**ADDENDUM # 1**

<b>Project</b>	TA Blakelock High School Renovations	<b>Project No.</b>	2215-C
<b>Location</b>	1160 Rebecca Street, Oakville, ON	<b>Date of Issue</b>	2025 04 24
<b>Owner</b>	Halton District School Board	<b>File</b>	2215/7.1.3

This Addendum forms part of the Contract Documents and amends the original Drawings and Specifications, dated 2025 04 17, and all preceding Addenda, as noted below.

3 PARTIAL FLOOR PLAN - LEVEL 0  
A101-D 1:50

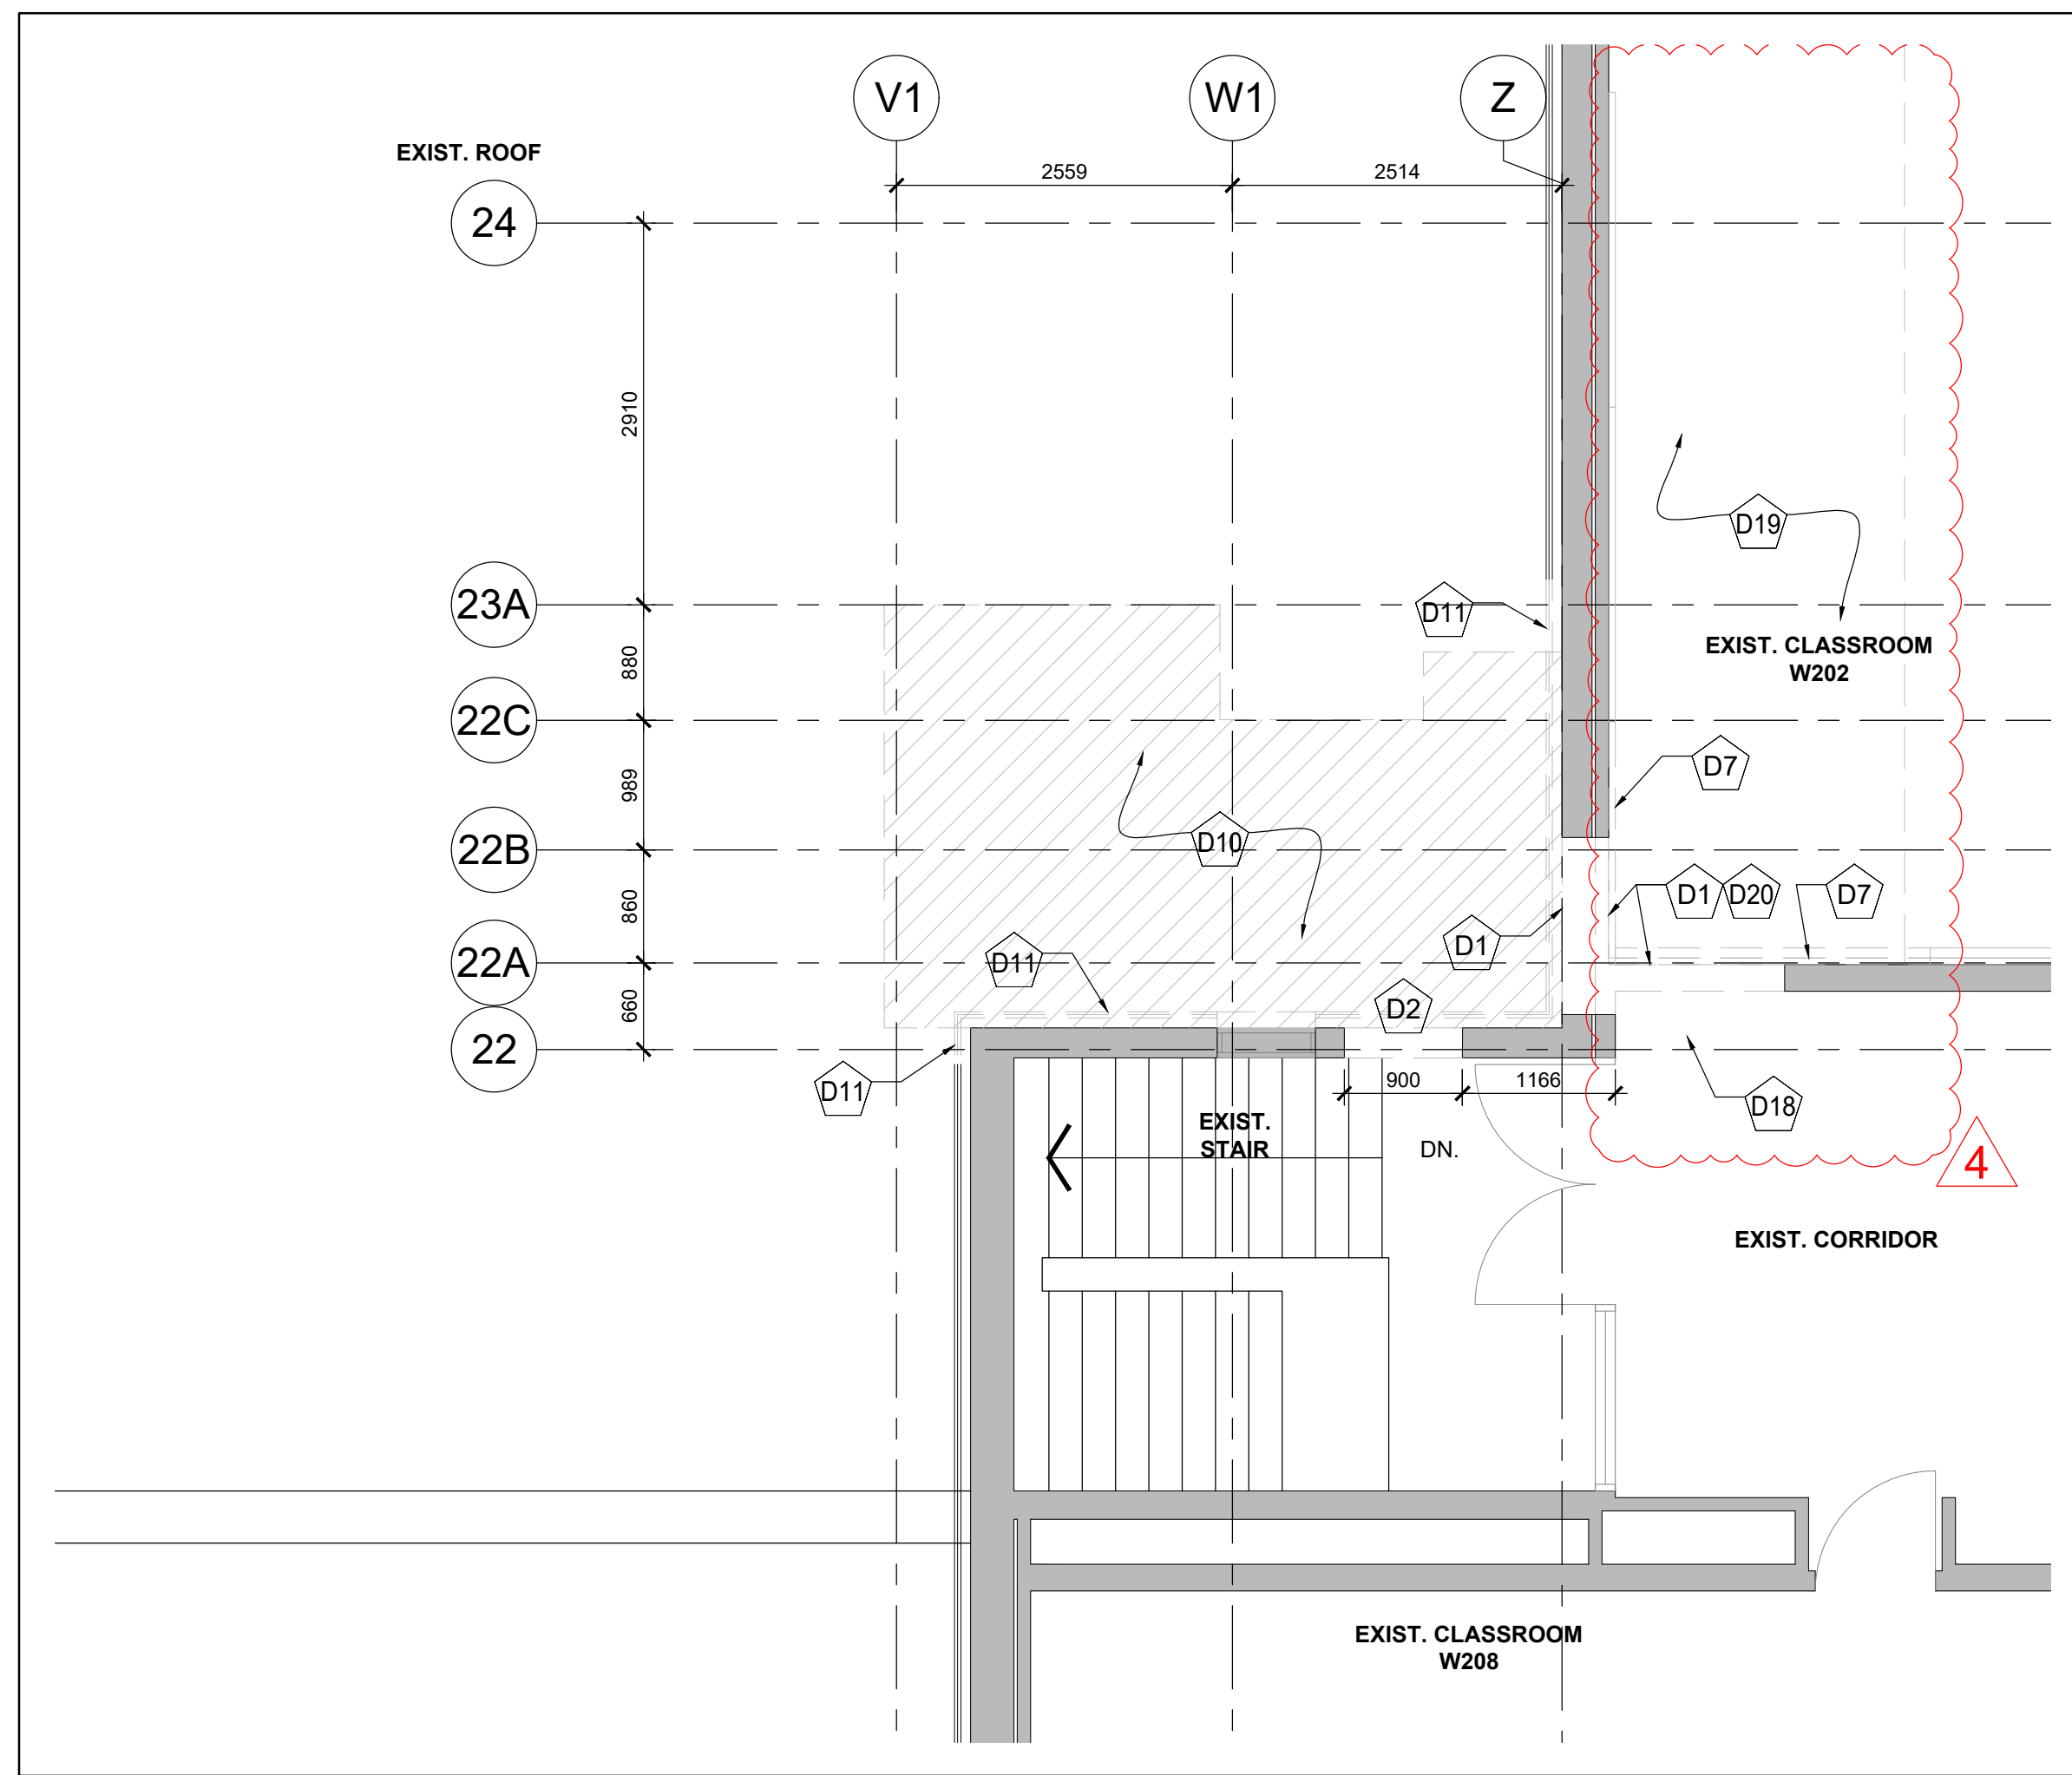
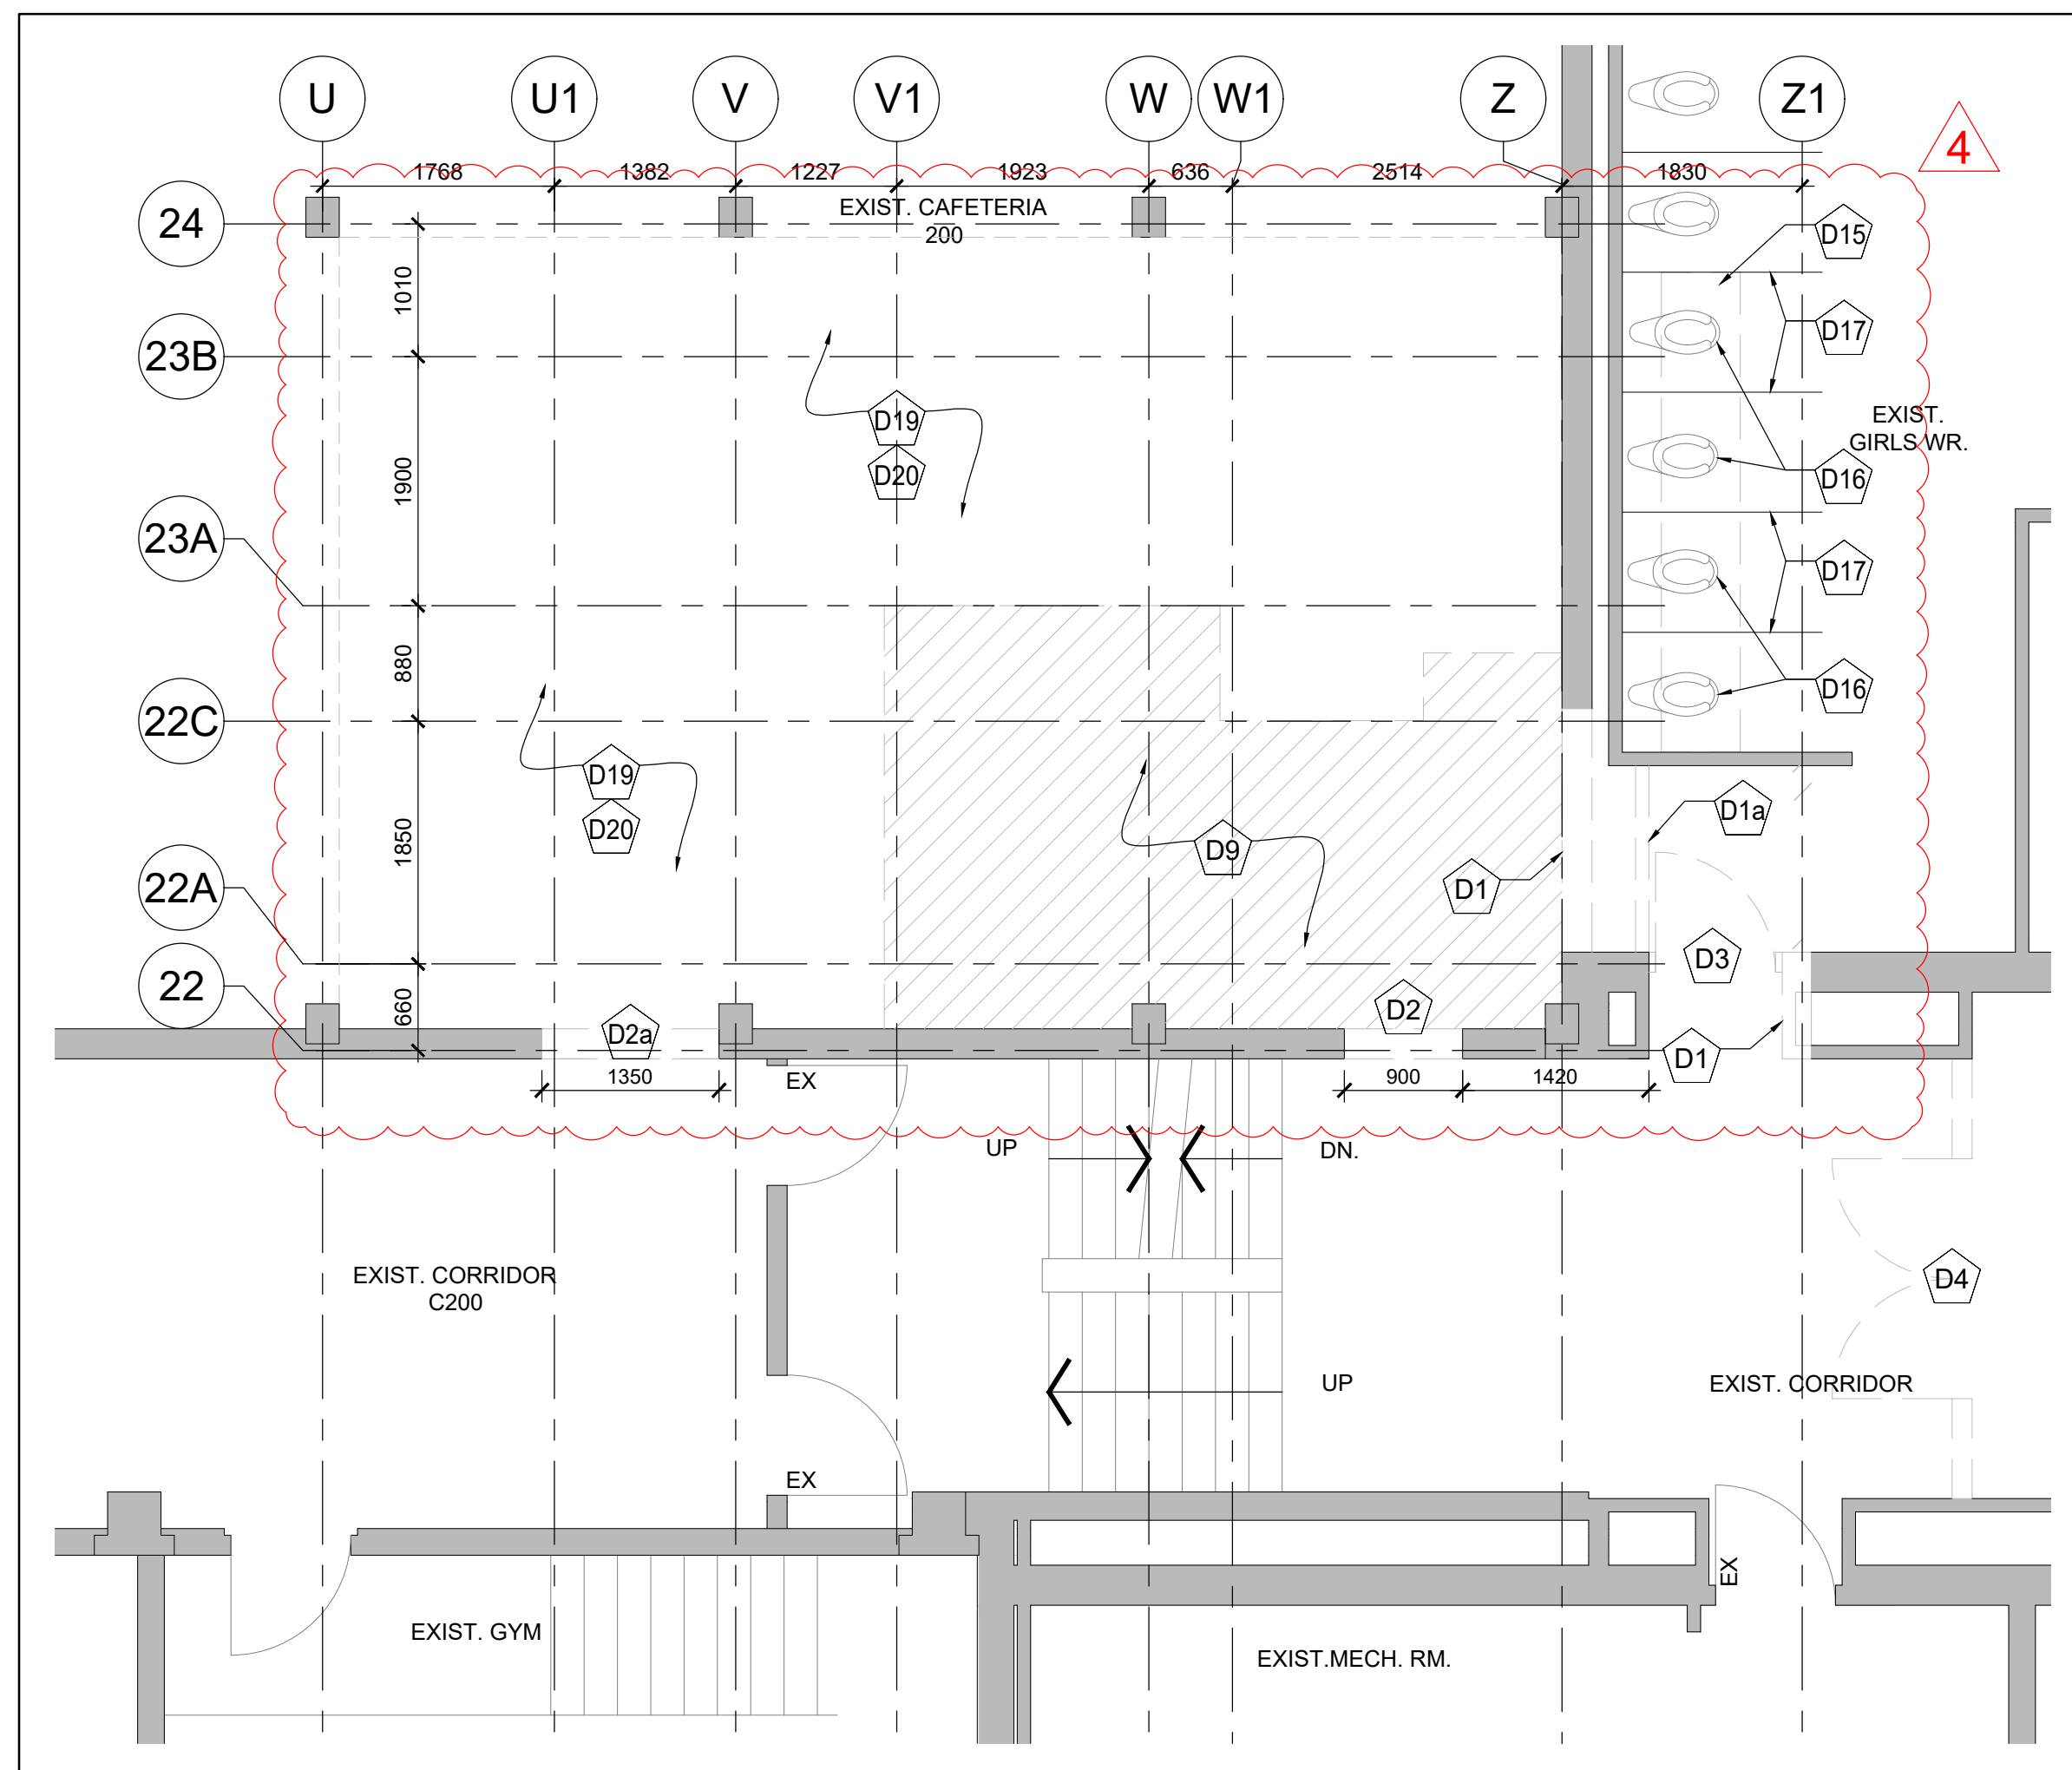
- .1 Replace drawing with the attached Revision No. 4.
- .2 Drawing reissued to clarify demolition scope and include additional Demolition Notes D15-D20.
